**APPEAL REF: APP/B1740/W/23/3324227**

**Description of Development: Demolition of the existing buildings and the erection of 25 dwellings with associated access, landscaping and parking.**

**Site: Orchard Gate, Noads Way, Dibden Purlieu Hampshire SO45 4PD**

## **Proof of Evidence – Thomas Callaway BSc (Hons), Hampshire County Council (LLFA)**

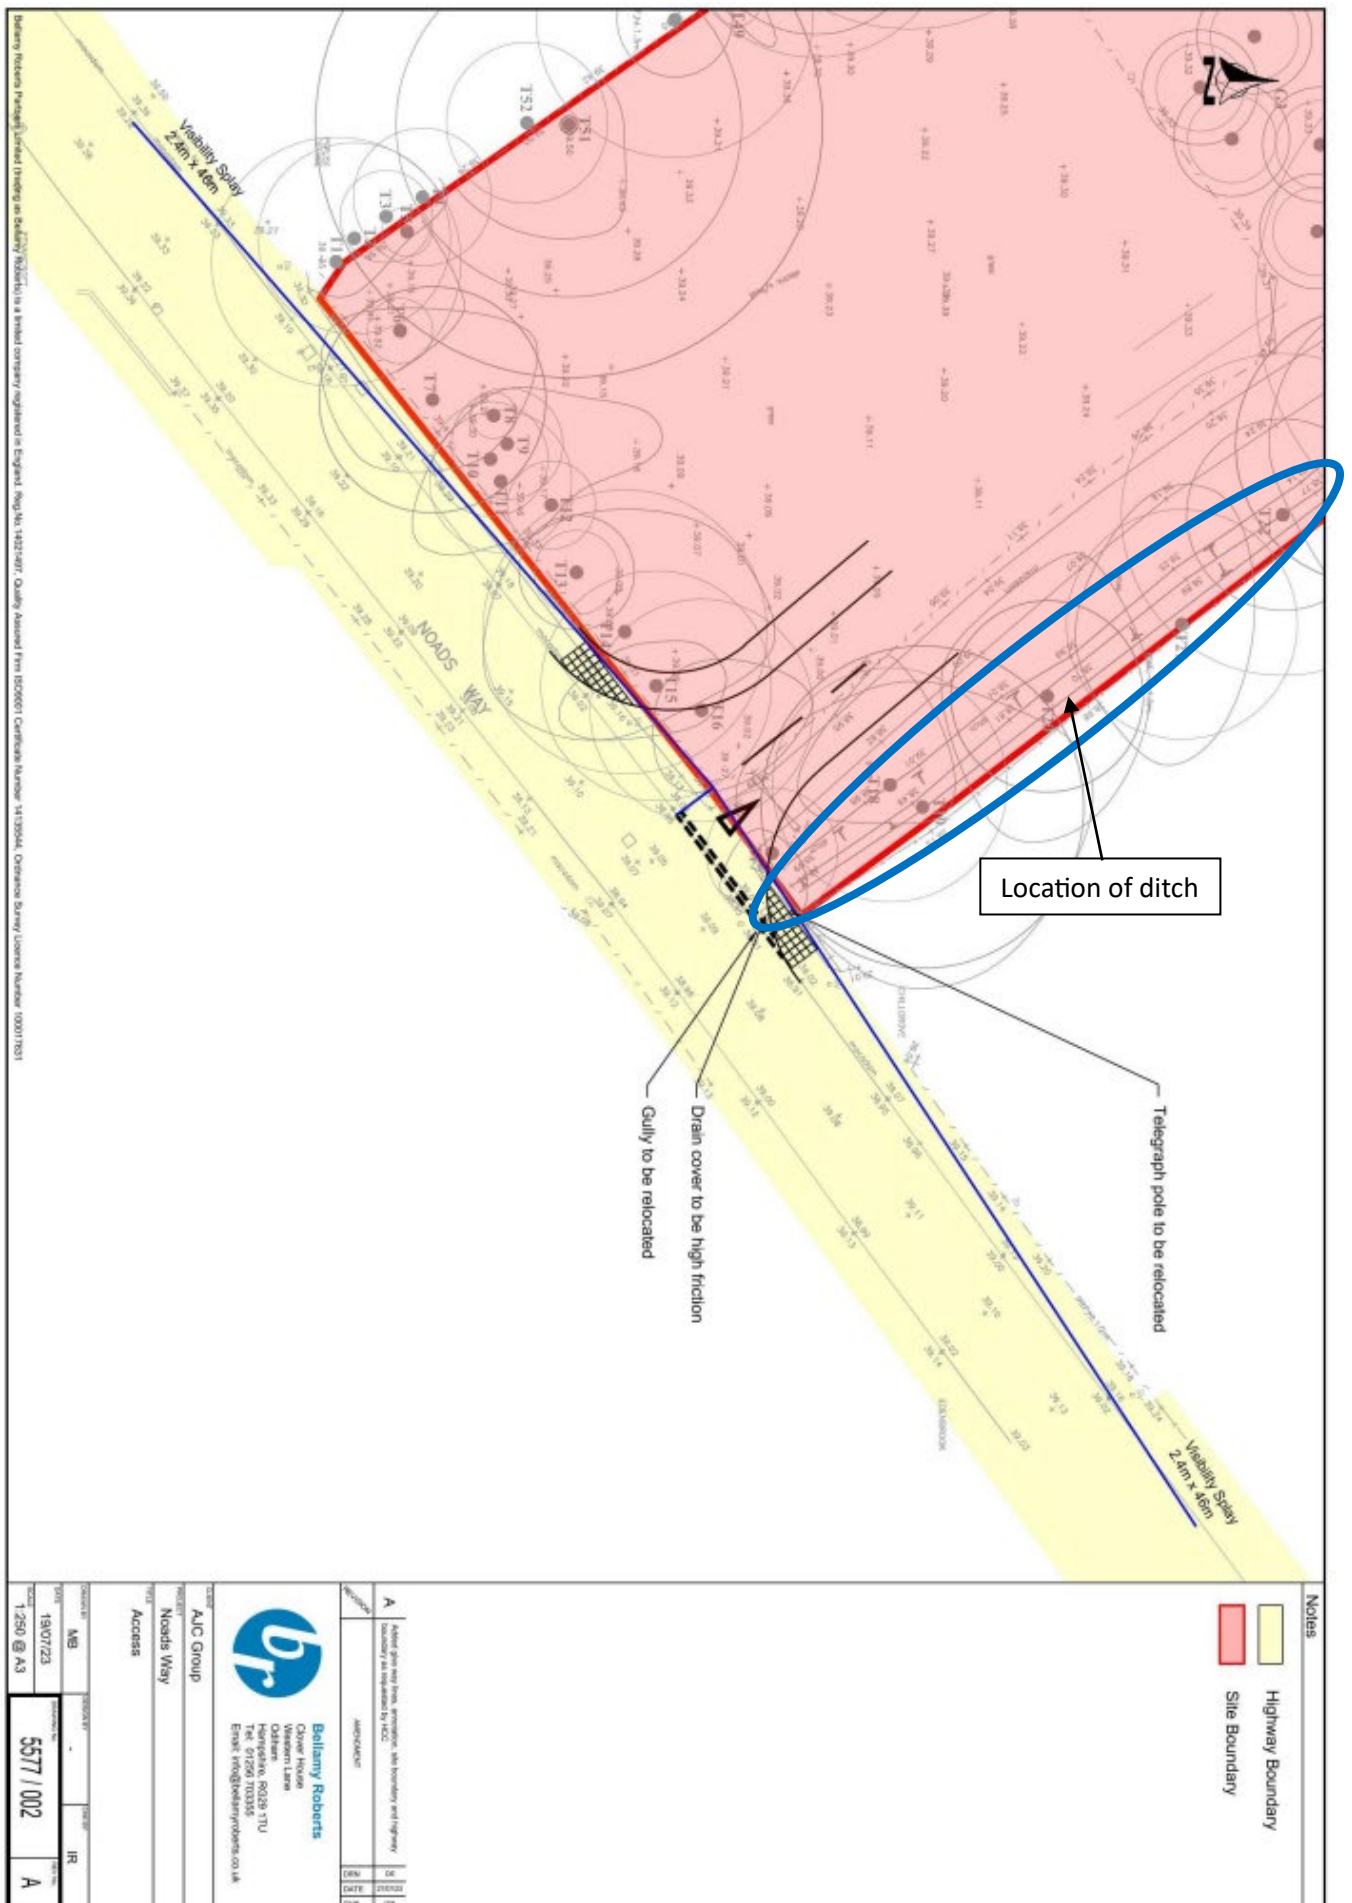
- 5.1. The LLFA considered that the main issue at this site was the choice of discharge location being the foul sewer, which is the least sustainable discharge location as described by The Building Regulations 2010, Planning Practice Guidance and CIRIA C753 The SuDS Manual (Appendix C). Water companies may have flood risk concerns regarding the extra loading to the sewerage infrastructure, including combined sewer overflows and treatment works.

- 5.5. The LLFA considered that the later infiltration test results should allow for infiltration drainage on the site, even if the whole site could not be drained by infiltration. This may allow for a reduced loading on the foul sewer if a connection was still required to drain the remainder of the site. Further information on peak groundwater levels would be required to support this strategy.

- 5.6. The LLFA suggested that the highway drainage system adjacent to the site in Noads Way should be investigated as a potential discharge location as it may rely on historic culverted land drainage. HCC Highways have since confirmed however that the piped system is in fact adopted and a connection from the site would probably not be permitted.

## Appendix A – Access plan from Bellamy Roberts correspondence

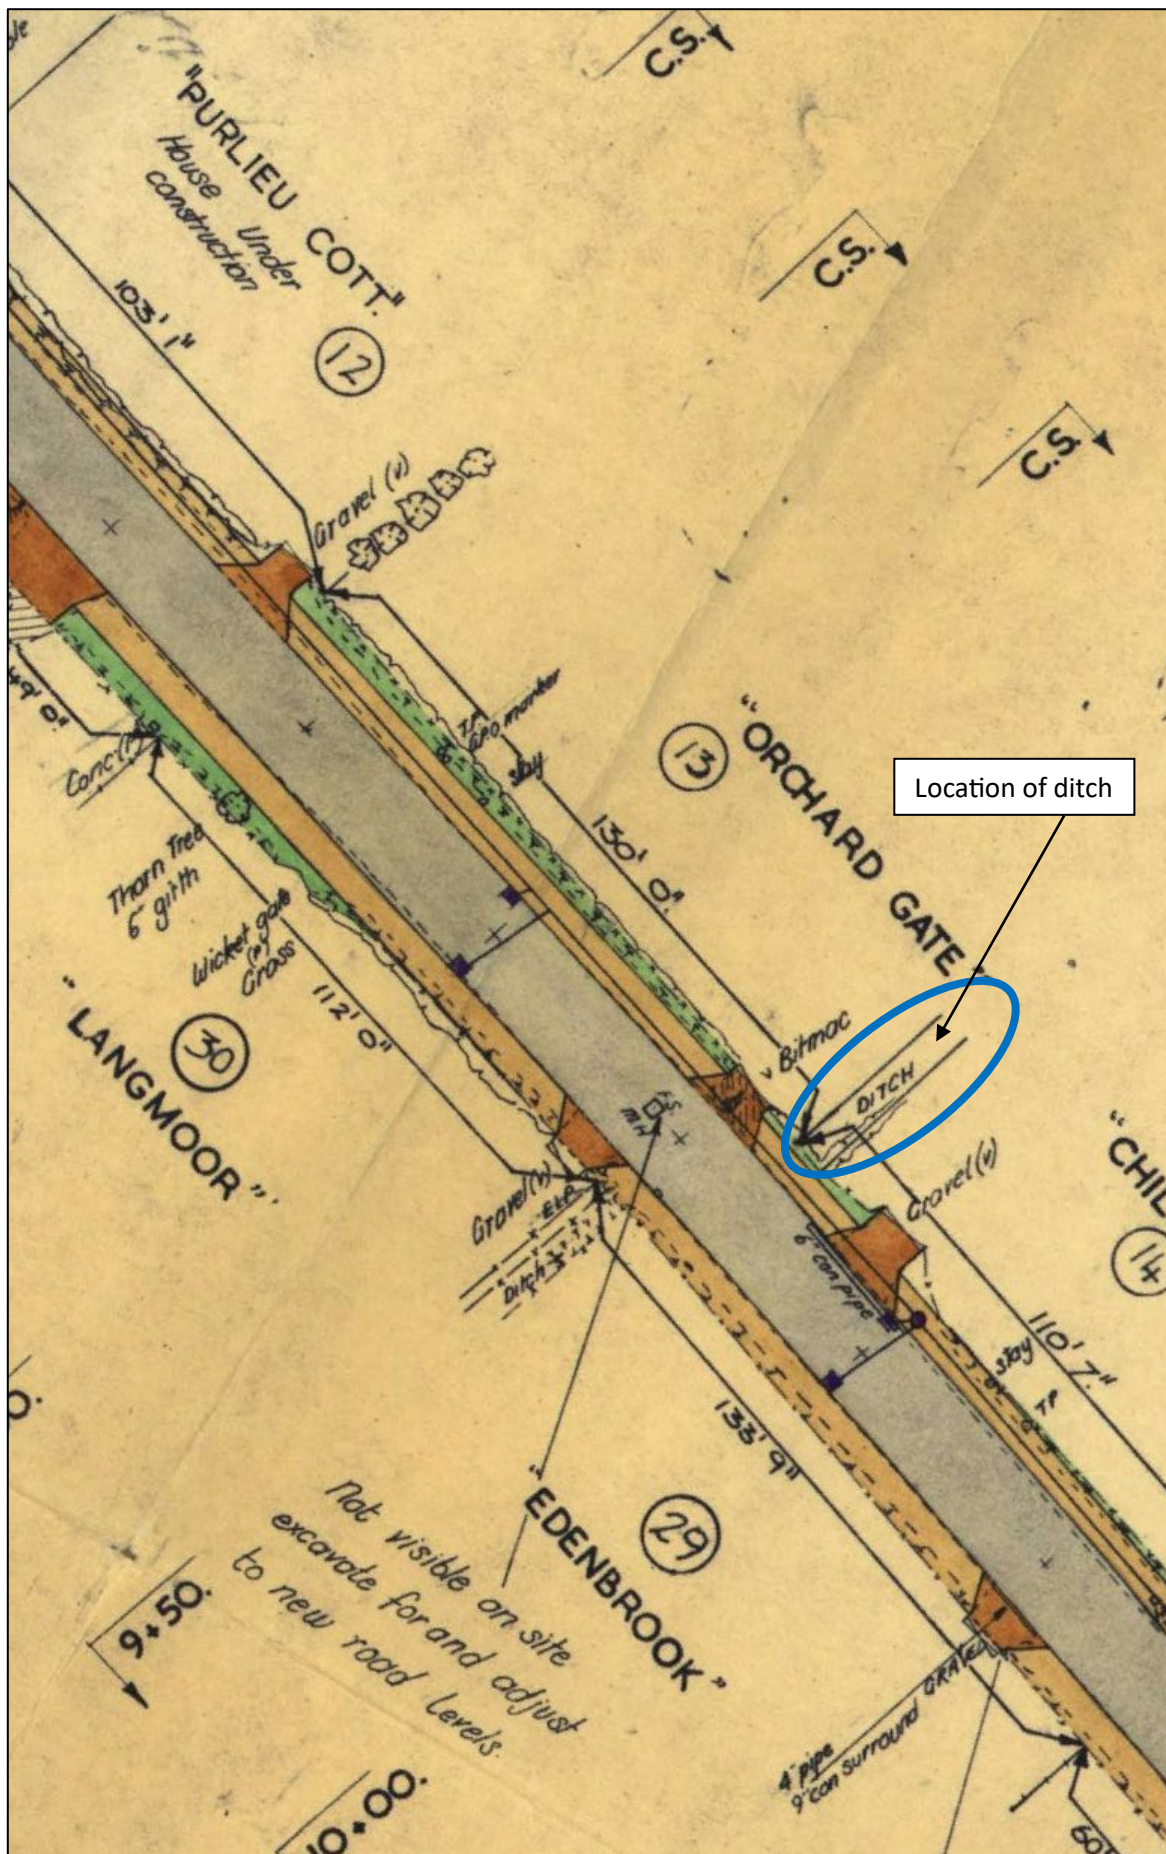
- 5.7. Correspondence relating to a Highways issue (Bellamy Roberts, ITR/557/sk, 4/8/23) was provided to the LPA and uploaded to the website on 7/8/23. This document included a drawing titled 'Access' (5577/002 A) showing the site boundary and highway boundary in relation to access details. The topographic survey can be seen on this drawing and shows a ditch feature within the eastern boundary of the site extending to the existing footway in the highway (Appendix A). Evidence of this ditch has also been found on a HCC highway adoption plan (Appendix B) – note that this ditch is not an adopted highway feature.

- 5.8. Many ditches and minor watercourses are not shown on mapping of any kind, therefore the LLFA will often trust a statement by an applicant that there are no watercourses available as a discharge location. However, if a discharge to a foul sewer is proposed, the LLFA will require further investigation into more sustainable discharge locations. This is because the water company may be relying on the LLFA being satisfied that all other options have been exhausted prior to giving approval for a connection to the foul sewer.

- 6.3. The whole site could also be drained at rates not exceeding greenfield runoff rates to a watercourse that exists within the site, a strategy that was not considered possible by the applicant in all previous correspondence. The LLFA would accept this as a drainage strategy if it is proposed by the applicant.
